**THE PUTNAM COMMUNITY FOUNDATION
SENIOR HOUSING DEVELOPMENT
FINAL ENVIRONMENTAL IMPACT STATEMENT**

Town of Carmel, New York

THE PUTNAM COMMUNITY FOUNDATION
SENIOR HOUSING DEVELOPMENT
FINAL ENVIRONMENTAL IMPACT STATEMENT (FEIS)

This Final Environmental Impact Statement (FEIS), prepared pursuant to the State Environmental Quality Review Act (SEQRA), provides responses to agency and public comments received by the lead agency on the Draft Environmental Impact Statement (DEIS) prepared for The Putnam Community Foundation Senior Housing project, Town of Carmel, Putnam County, New York. The FEIS has been prepared in accordance with Section 8-0101, et. seq. of the Environmental Conservation Law and the regulations promulgated by the New York State Department of Environmental Conservation (NYSDEC) thereunder, which appear at 6 NYCRR, Part 617.

Figure 3.5-3: FEIS Site Plan
Putnam Community Foundation
 Town of Carmel, Putnam County, New York
 Source: Insite Engineering, Surveying & Landscape Architecture, P.C.
 Revision Date: 08/08/08
 Scale: As shown

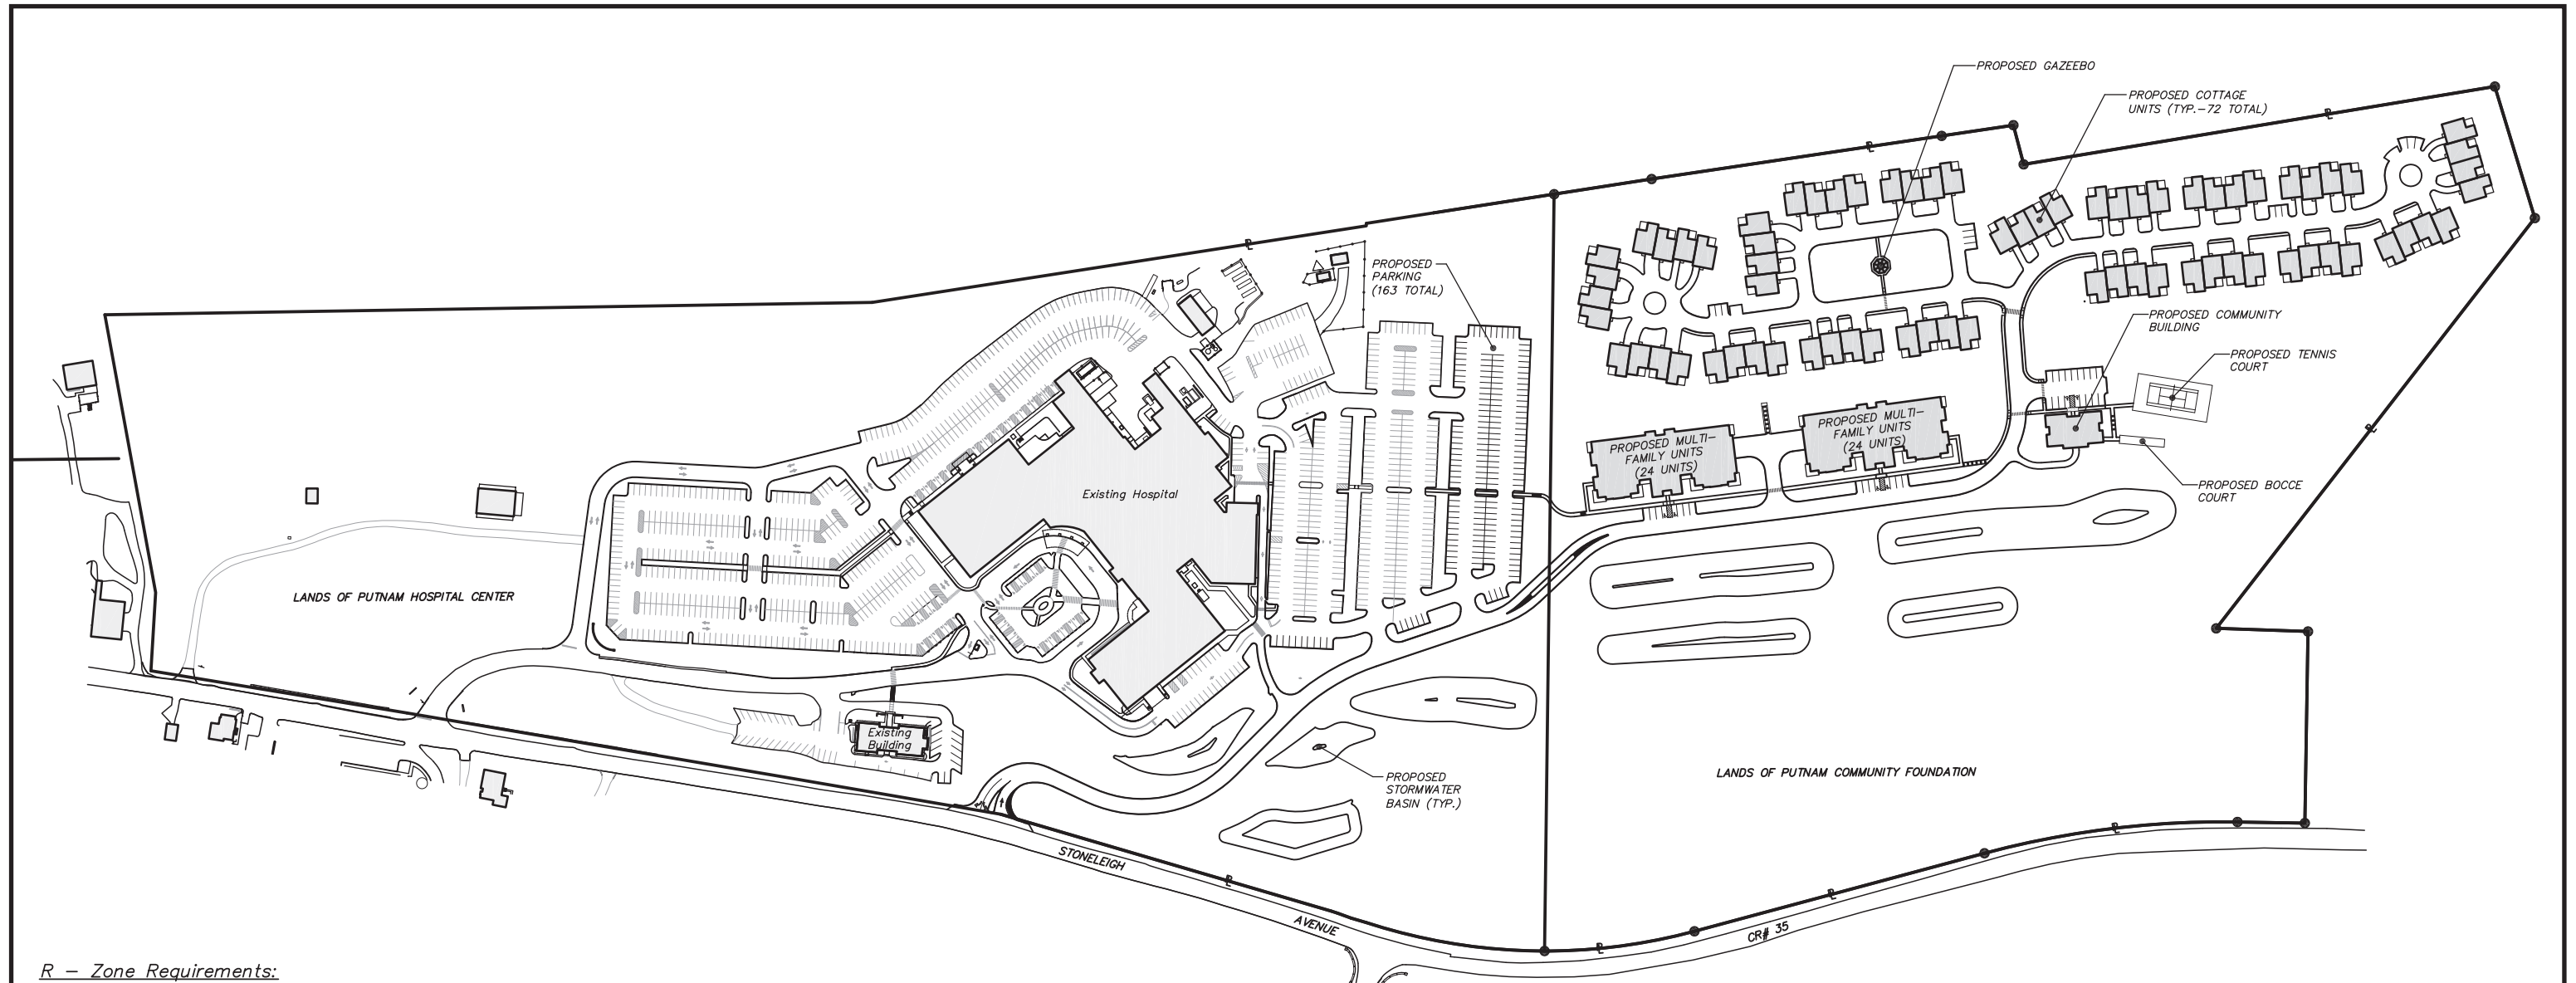
Comment 3.1-5 (Letter #1, Marilyn Shanahan, DEP, September 21, 2007): An erosion and sediment control drawing is included as Figure 3.1-5, This drawing will require substantial revision before mitigation of construction impacts can be demonstrated. For instance, the initial staging area is in the vicinity of a future detention basin along Stoneleigh Avenue. The area is very steep, having slopes over 20%. In addition, it is immediately upslope of a culvert carrying runoff into Croton Falls Reservoir. The alignment of the temporary haul road from this area extends uphill through areas that are sloped on the order of 40%.

The Proposed Action has been modified in response to comments raised and concerns expressed during the review of the Putnam Community Foundation DEIS. FEIS Figure 3.5-1, Local Roads, shows the intersections of concern including the revised site access on the Putnam Community Hospital property. The site access has been moved to create a direct connection between the project site and the Putnam Community Hospital and to share an access with the Putnam Community Hospital. The hospital will retain their existing access and will have the shared access as a second access. The two access configurations are shown in FEIS Figures 3.5-2 (DEIS Plan) and 3.5-3 (FEIS Plan).

Response 3.1-5: *Comment noted; access to the site through the area noted in the comment is no longer proposed. Refer to Responses 3.1-3 , 3.1-5 and FEIS Figure I-1.*
